Access Compliance Report

Public Rights-of-Way

Intersection ID: 28015	Main Street: LANCASTER_HY	Cross Street: PROVIDENCE_RD_WEST	Location: SW
ADA ID: 0DB3EC14BB2E	Ramp Type: Perp	Initial Pass/Fail: Pass	Overall Compliance: No
Severity Score: 0			
Codes/Mitigation Info/Possible Solution		Field Measurements/Component Compliance

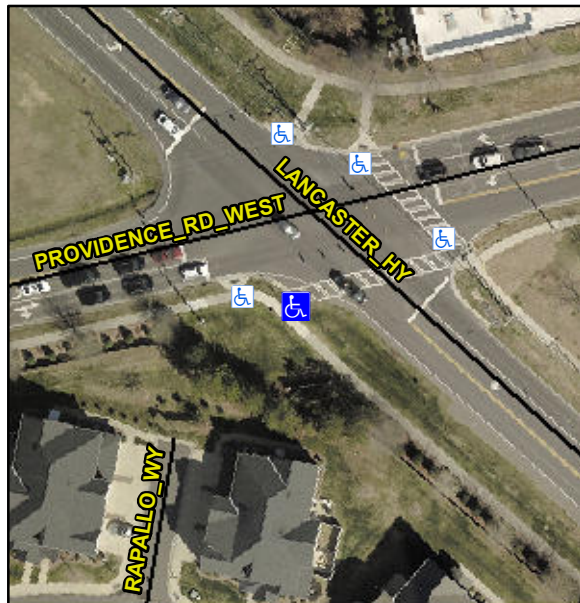
Not Found, R304.2.1, R304.2.2-Perp, R304.3.2-Para

Compliance	Description	Data	Compliance	Description	Data
N/A	Ramp Length (in)	25.5	Yes	Ramp Slope (%)	5.7
Yes	Ramp Width (in)	57.0	Yes	Ramp XSlope (%)	1.4
Yes	Flare Type L	Curbed_NoWalkSurface	Yes	Flare Type RT	N/A
Yes	Flare Slope LT (%)	N/A	N/A	Flare Slope RT (%)	N/A
N/A	Flare Traversable LT?	No	N/A	Flare Traversable RT?	No
No	Landing Length (in)	45.5	Yes	DWS Provided?	Yes
Yes	Landing Width (in)	58.0	Yes	DWS Contrast?	Yes
No	Landing Slope (%)	2.9	Yes	DWS Length (in)	24.0
Yes	Landing X Slope (%)	1.8	Yes	DWS Full Width?	Yes
N/A	Landing Curb? (Y/N)	No	Yes	DWS Offset (in)	0.0
N/A	Shared Landing?	No			
Yes	Gutter Ponding?	No	Yes	Gutter Slope (%)	0.3
Yes	Gutter Lip Ht (in)	0.0	Yes	Gutter X Slope (%)	1.3
N/A	Painted X Walk1?	No	N/A	Painted X Walk2?	N/A
	X Walk 1 Direction	To NE		X Walk 2 Direction	N/A
N/A	X Walk 1 Width (in)	N/A	N/A	X Walk 2 Width (in)	N/A
	X Walk 1 Slope (%)	1.4		X Walk 2 Slope (%)	N/A
	X Walk 1 X Slope (%)	2.3		X Walk 2 X Slope (%)	N/A

Remove & Replace Entire Ramp.
